STAFF RECOMMENDATION
2114 19th Avenue South
February 15, 2012

Application: Infill
District: Belmont-Hillsboro Neighborhood Conservation Zoning Overlay
Council District: 18
Map and Parcel Number: 10416002500
Applicant: Michael Ward, Allard Ward Architects
Project Lead: Melissa Baldock, melissa.baldock@nashville.com

<p>Description of Project: Applicant proposes to construct a two- and one-half story house.</p> <p>Recommendation Summary: Staff recommends approval of the construction of the infill building with the conditions that:</p> <ol style="list-style-type: none"> 1. The house be setback from the front property line sufficiently so that it is in line with the historic house to its left. 2. Staff review and approve the color of the asphalt shingle and standing seam roof colors; all windows and doors; and the shake material prior to purchase and installation of these materials. 3. HVAC be located at the rear of the home or on the side, beyond the mid-point of the house; and 4. The existing central walkway be retained or reconstructed. <p>With these conditions, staff finds that the project meets the Belmont-Hillsboro Neighborhood Conservation Zoning Overlay design guidelines.</p>

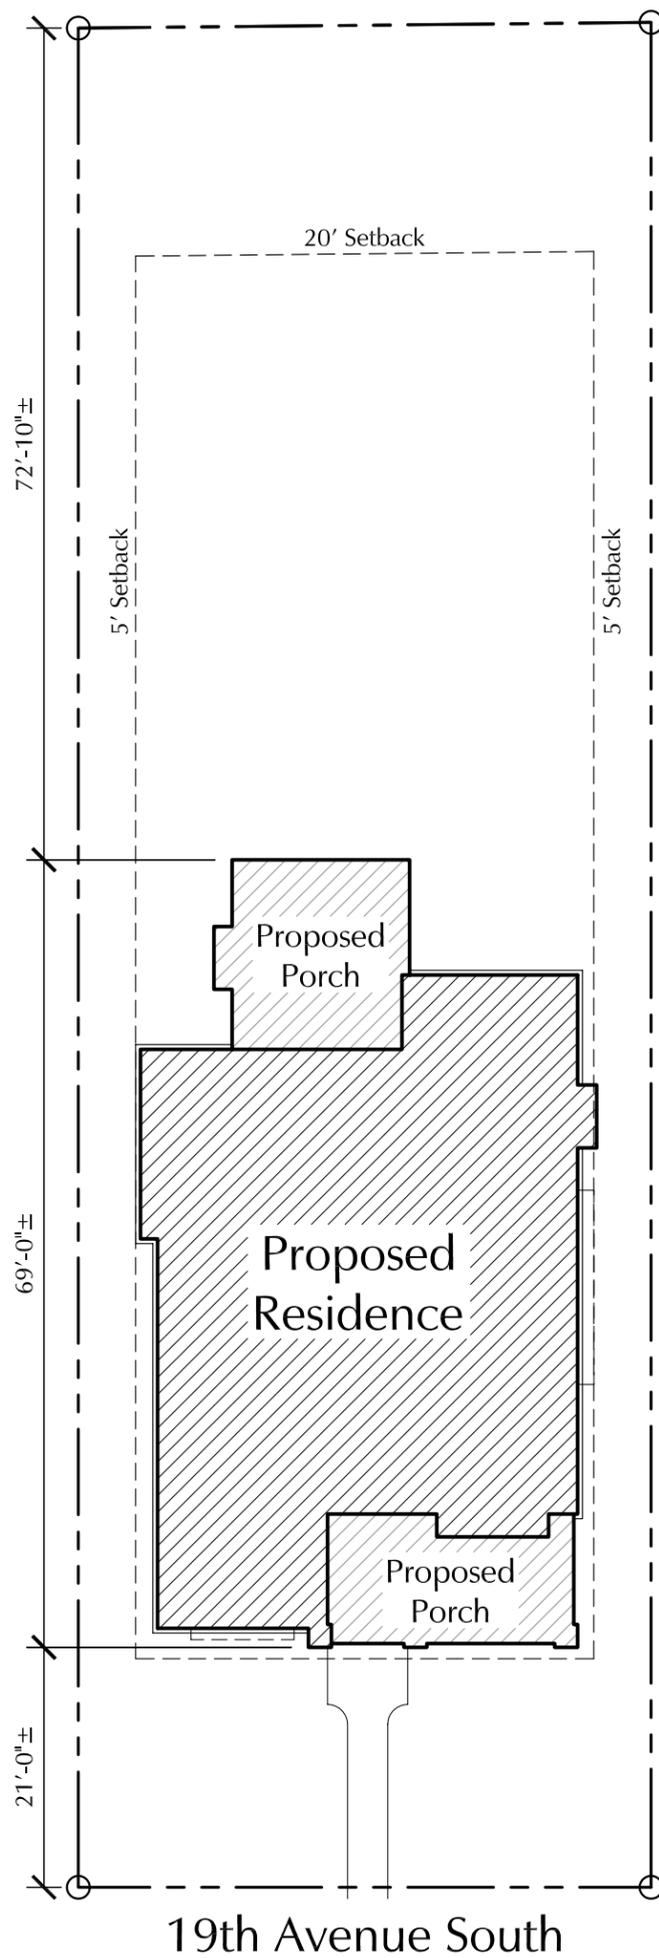
Houses to the left of the site. The new structure should match the front setback of this house.

Site Development Plan

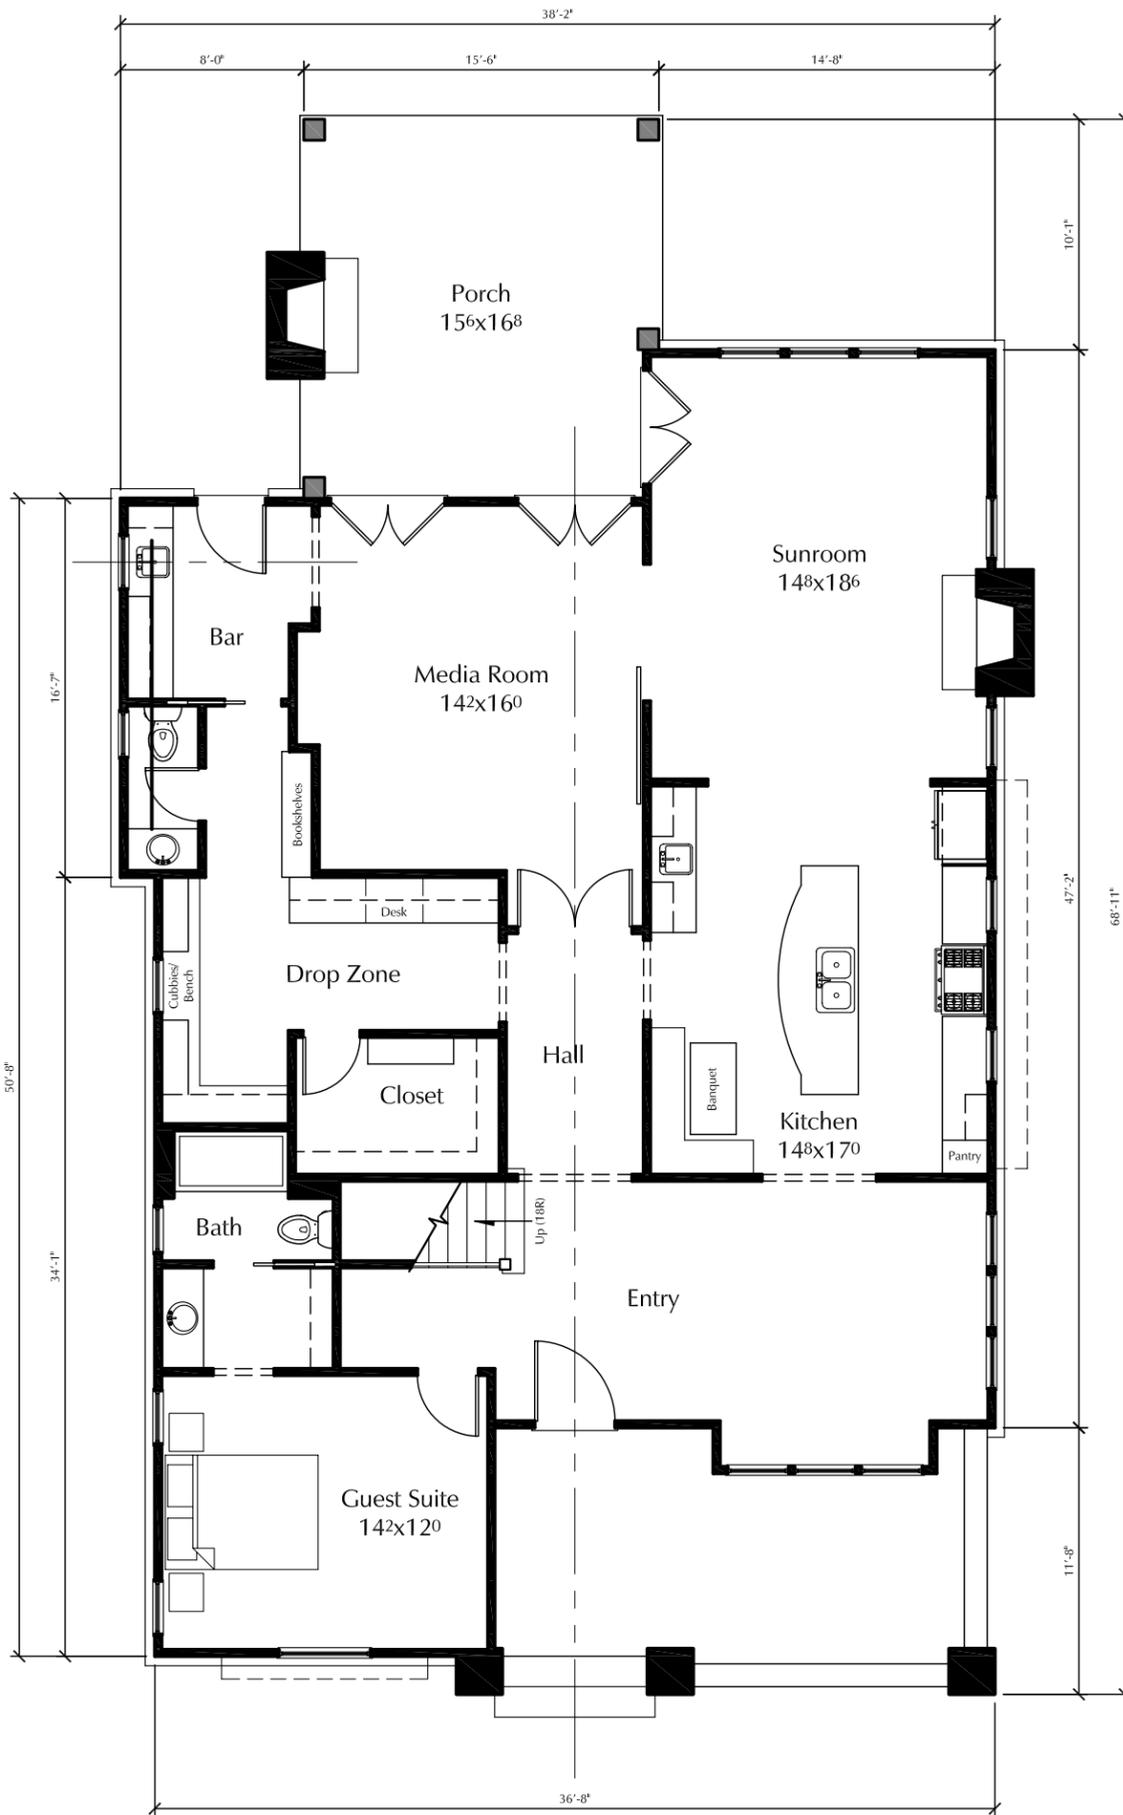
Setback and Location: The proposal meets all bulk zoning setback requirements. The primary building is centered on the lot, similar to other historic buildings found in the district. However, the house is setback from the front property line twenty-one feet (21'), whereas the historic house to its left is located approximately forty feet (40') from the front property line. Staff recommends that the proposed house be pushed back from the front property line so that it lines up with the house next door. This will require that the applicant accurately measure the setback of the house next door.

Orientation: The proposed structure has an asymmetrical façade with a centered front entrance and a porch located on the right portion of the front façade. The house is oriented to face 19th Avenue South, as are all of the buildings on this block. There is an existing central concrete walkway that staff recommends keeping or reconstructing.

If the applicant pushes the house back to match the front setback of the historic house to its left, then staff finds the setback and location of the proposed structure to meet Section II.B.1.c. of the *Belmont-Hillsboro Neighborhood Conservation Zoning Overlay Handbook and Design Guidelines*.

1. The house be setback from the front property line sufficiently so that it is in line with the historic house to its left.
2. Staff review and approve the color of the asphalt shingle and standing seam roof colors; all windows and doors; and the shake material prior to purchase and installation of these materials.
3. HVAC be located at the rear of the home or on the side, beyond the mid-point of the house; and
4. The existing central walkway be retained or reconstructed.

Front Elevation

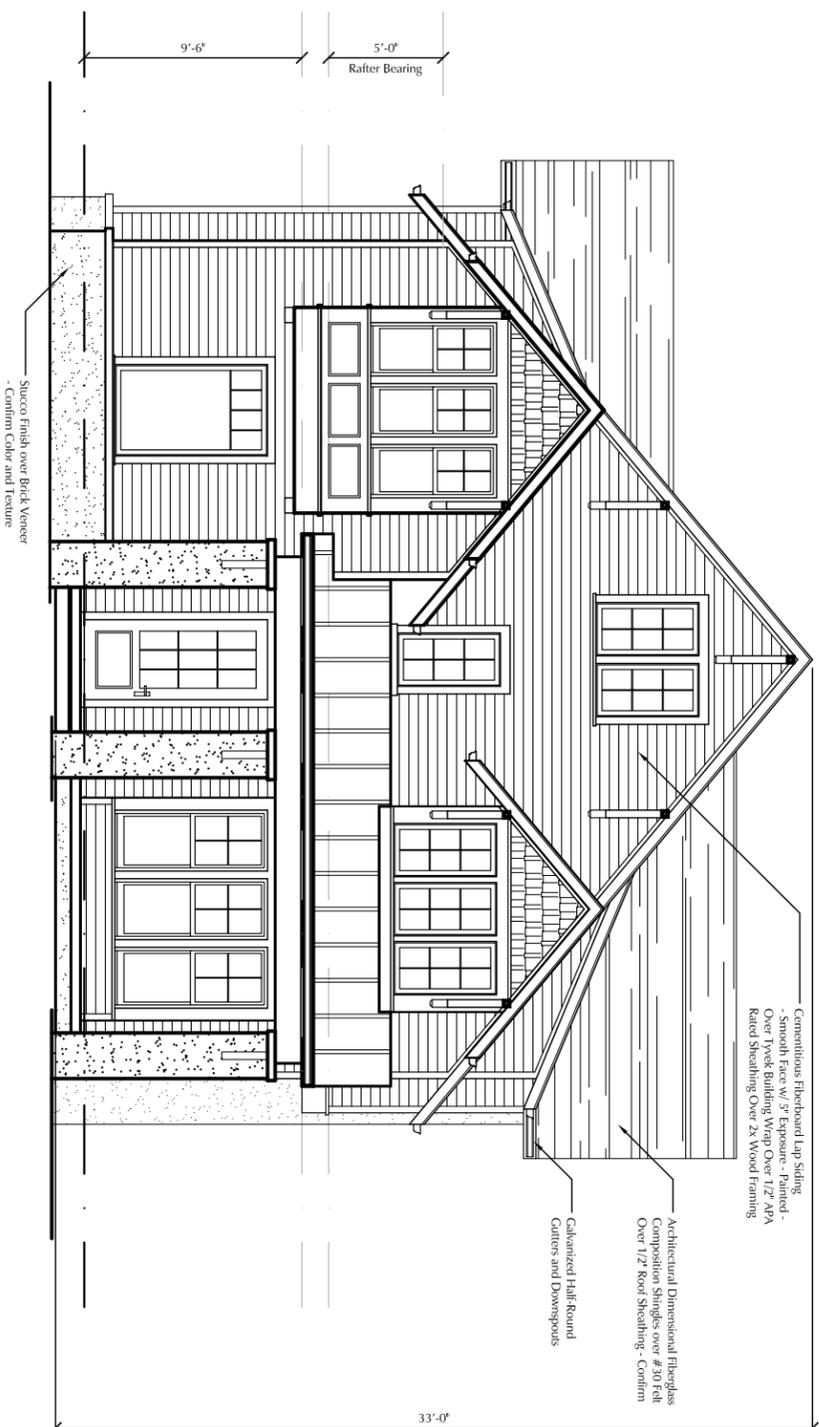
Height & Scale: The proposed dwelling is two- and one-half stories, and is thirty-three feet (33') from grade to ridge. The majority of homes in the immediate context are one- and one-half stories; however, there are multiple two- and three-story buildings in the district and in the immediate area. The two-story historic house to the left is approximately thirty two feet, three inches (32' 3") from grade and the three-story apartment building across the street is approximately forty-one feet, four inches (41' 4"). The primary foundation height is approximately two feet, nine inches (2'9"), although it is only approximately one foot, three inches (1'3") at the porch.

Roof: The primary roof form is a front gable with a slope of approximately eleven-twelve (11/12). The front façade has a front-gabled projecting bay that also has a roof slope of eleven-twelve (11/12). The dormers and bays on the side and rear elevations also all largely have roof slopes of eleven-twelve (11/12), with the exception of some dormers on the side facades that have shed roof forms.

Proportion and Rhythm of Openings: The windows of the proposed structure are approximately twice as tall as they are wide, with the exception of some more utilitarian windows on the side and rear facades. The windows therefore meet the historic ratio of windows in the neighborhood. There is no large area of any of the façades without a window or door opening.
